Access Compliance Report

Public Rights-of-Way

Intersection ID: 27872	Main Street: BALLANTYNE_COUNTRY_CLUB_DR	Cross Street: LETHCO_WY	Location: S
ADA ID: 2D1995C777D7	Ramp Type: BlendTrans2	Initial Pass/Fail: Fail	Overall Compliance: No
		Severity Score: 25

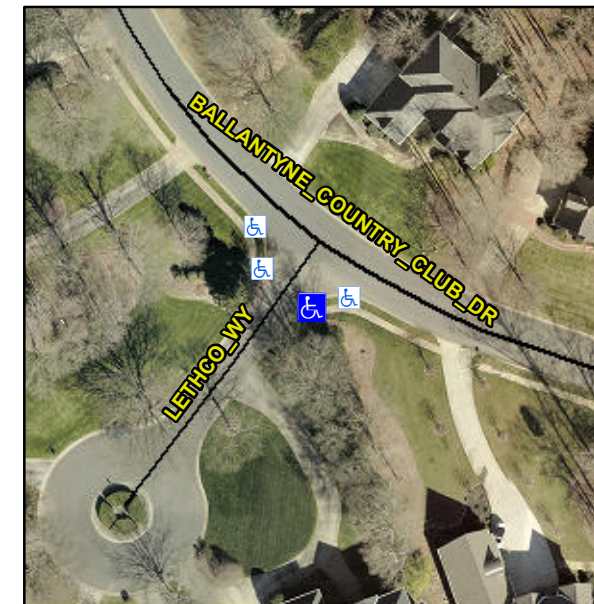
Not Found, R304.5.3

Compliance	Description	Data	Compliance	Description	Data
N/A	Ramp Length (in)	96.0	Yes	BlendTrans Slope (%)	1.1
Yes	Ramp Width (in)	48.0	No	BlendTrans XSlope (%)	9.5
N/A	Flare Type LT	N/A	N/A	Flare Type RT	N/A
N/A	Flare Slope LT (%)	N/A	N/A	Flare Slope RT (%)	N/A
N/A	Flare Traversable LT?	N/A	N/A	Flare Traversable RT?	N/A
N/A	Landing Length (in)	N/A	N/A	DWS Provided?	N/A
N/A	Landing Width (in)	N/A	N/A	DWS Contrast?	N/A
N/A	Landing Slope (%)	N/A	N/A	DWS Length (in)	N/A
N/A	Landing X Slope (%)	N/A	N/A	DWS Full Width?	N/A
N/A	Landing Curb? (Y/N)	N/A	N/A	DWS Offset (in)	N/A
N/A	Shared Landing?	N/A			
N/A	Gutter Ponding?	N/A	N/A	Gutter Slope (%)	N/A
N/A	Gutter Lip Ht (in)	N/A	N/A	Gutter X Slope (%)	N/A
N/A	Painted X Walk1?	No	N/A	Painted X Walk2?	N/A
	X Walk 1 Direction	To NW		X Walk 2 Direction	N/A
	X Walk 1 Width (in)	N/A		X Walk 2 Width (in)	N/A
	X Walk 1 Slope (%)	3.8		X Walk 2 Slope (%)	N/A
	X Walk 1 X Slope (%)	7.1		X Walk 2 X Slope (%)	N/A

N/A	Ramp inside XWalk1?	N/A	N/A	Ramp inside XWalk2?	N/A
	Road Slope (%)	7.1		Clear Space?	N/A
	Road X Slope (%)	3.8	N/A	Clear Space to XWalk (in)	N/A
N/A	Any Obstructions?	N/A	N/A	Storm Grate/Utility Hazard?	N/A
	Obstruction Type			Storm Grate/Utility Type	
		N/A			N/A
			Yes	Surface Condition? (G/P)	Good
			No	Curb Slope (%)	15.0

Remove & Replace Curb Ramp With Two New Directional Ramps or Equivalent.
